Task Force on Harbourfront Developments on Hong Kong Island

TFHK/06/2015

Land Use Review on the Western Part of Kennedy Town

圖 PLAN
3

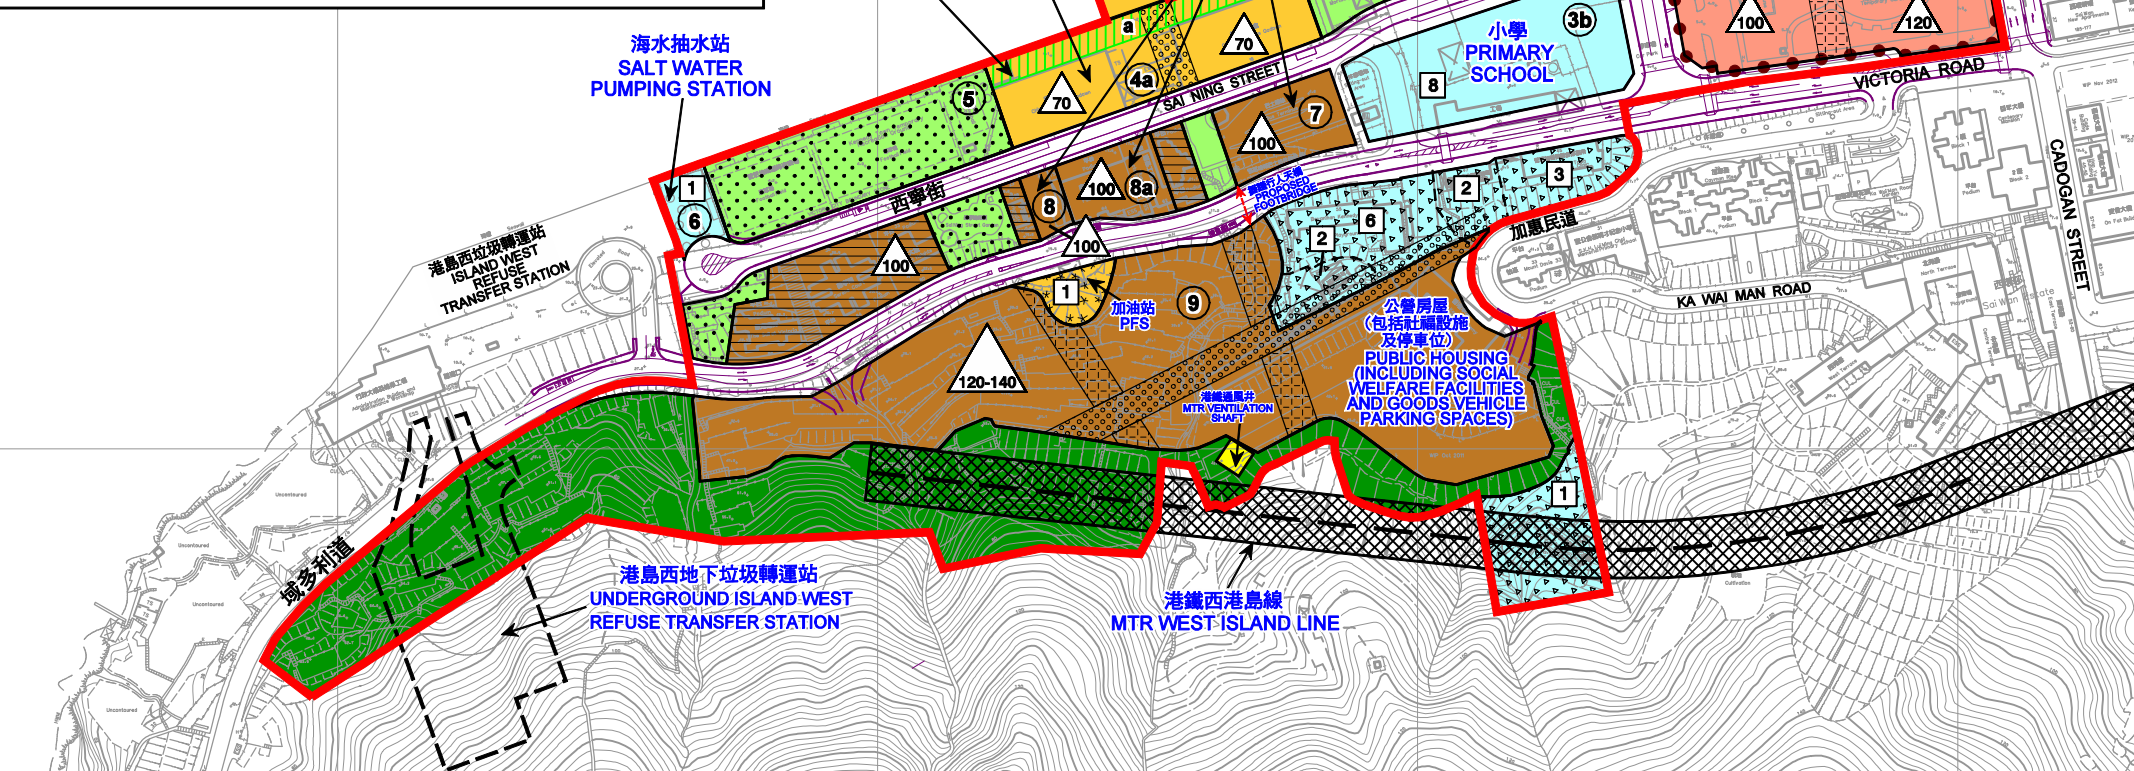
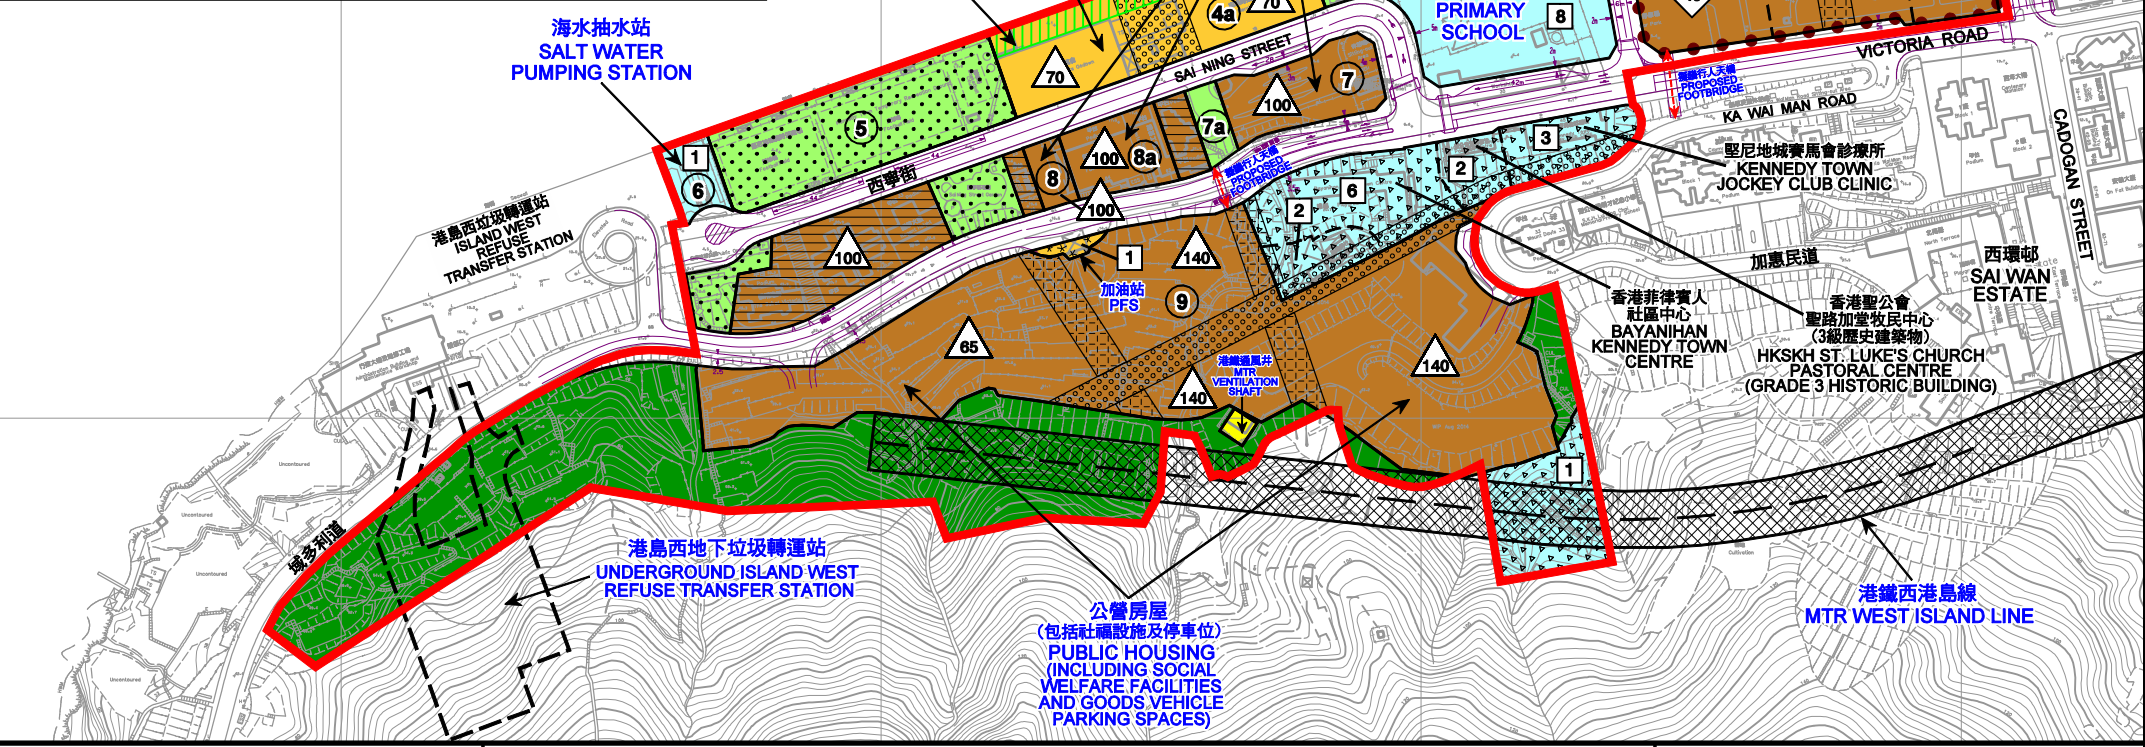
Accessibility to the Waterfront

- (i) pedestrian connectivity to the waterfront should be enhanced;
- (ii) the proposed new access road should be shortened to provide a direct access to the waterfront as far as possible;
- (iii) marine access to the promenade should be considered;

Location and Design of Private Housing Development at Site 3a

- (iv) swapping of the primary school at Site 3b and the private housing development at Site 3a was proposed;
- (v) the proposed public transport interchange (PTI) at Site 3a should be well integrated with the future topside residential development;

Arch and Foundation Stone of the Ex-Tung Wah Small Pox Hospital

- (vi) the arch and foundation stone of the ex-Tung Wah Small Pox Hospital should be retained at its current location; and

Extension of Tramway Line

- (vii) extension of tramway to serve the proposed residential developments should be considered if the proposed access road was wide enough.

- (i) a section of the proposed new access road between the waterfront promenade and the primary school site is deleted. This will avoid the separation with the waterfront and result in an addition of 2,000m² of open space;
- (ii) the western pavement along Cadogan Street leading to the waterfront will be widened and a total of two footbridges across Victoria Road will be provided. Other detailed pedestrian facilities including crossings will be considered in the detailed design of the road improvement works;
- (iii) the existing piers along the waterfront will be retained and their pier function will be allowed while suitable new commercial, leisure and recreation uses of the piers are also proposed to enhance their vibrancy. This will allow the flexibility for the proposed marine access as well as the design of a vibrant promenade at the detailed design stage;

- (iv) the proposed 8-storey primary school at Site 3b, together with the existing low-rise government, institution or community (GIC) developments near the junction of Victoria Road and Ka Wai Man Road, will provide a continuous visual break in the surrounding

cluster of high-rise developments. In addition, the proposed PTI at Site 3a will replace both bus termini at Sai Ning Street and Shing Sai Road. The proposed location is to serve the existing and proposed developments in the Kennedy Town;

- (v) the PTI will be provided underneath the residential development and suitable integration will be considered at the detailed design stage. Notwithstanding this, the size of PTI will be minimised as far as practicable in order to release more spaces for GIC facilities. A basement carpark for private cars and goods vehicles will also be accommodated at this site;

- (vi) the subject arch and foundation stone are currently located at a small garden next to the Sai Ning Street bus terminus, which is not their original location. They are proposed to be relocated to the waterfront promenade for a better setting for conservation; and

- (vii) the proposed widening of existing roads is mainly to increase their capacity for road traffic. Currently, TD has no plan to extend the tramway line.
